27 Queen Street, MOE

Consent under Clause 52.20
(Victoria's Big Housing Build)

Consent under Clause 52.20 Officer Assessment
Development Approvals & Design

Figure 8. Proposed Landscape Plan

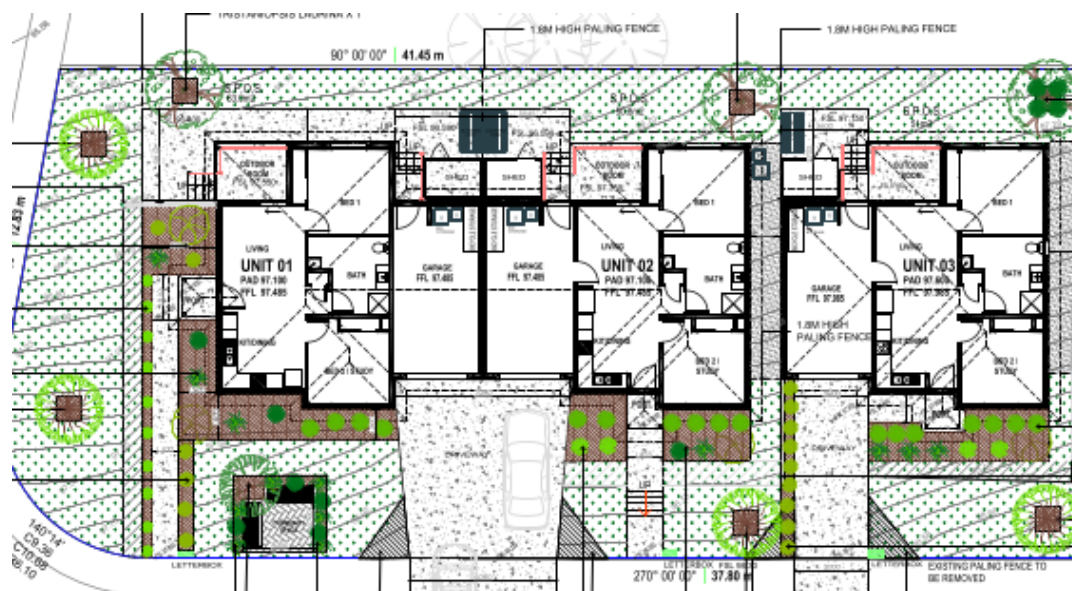
60. The overall landscaping and communal area located in front of Unit 1 is considered acceptable and will afford a high level of amenity for the future residents. The proposal seeks to remove two (2) trees located on the north-eastern boundary; however, seek to reintroduce native trees within each dwellings SPOS, as well as the streetscape. DTP therefore considers the tree removal to facilitate works (in particular, tree #2) appropriate within this context. Refer to Figure 6 for example of trees proposed within dwelling SPOS and Figure 7 for trees in streetscape.

62. Plant species have been selected in accordance with Latrobe City's '*Indigenous Plants of Latrobe City*' document and will incorporate Golden Wattle (*Acacia Pycnantha*), Kanooka Gum (*Tristaniaopsis laurina*), Dwarf Magnolia (*Magnolia grandiflora* little gem) and Blackwood (*Acacia melanoxylon*) tree species, along with Gristle Fern (*Blechnum Cartilagineum*), Soft Tussock-grass (*Poa Morissii*), Pale Grass-lily (*Caesia parviflora*), Blackanther Flax-lily (*Dianella revoluta*), and Grass Trigger-Plant (*Stylidium graminifolium*).
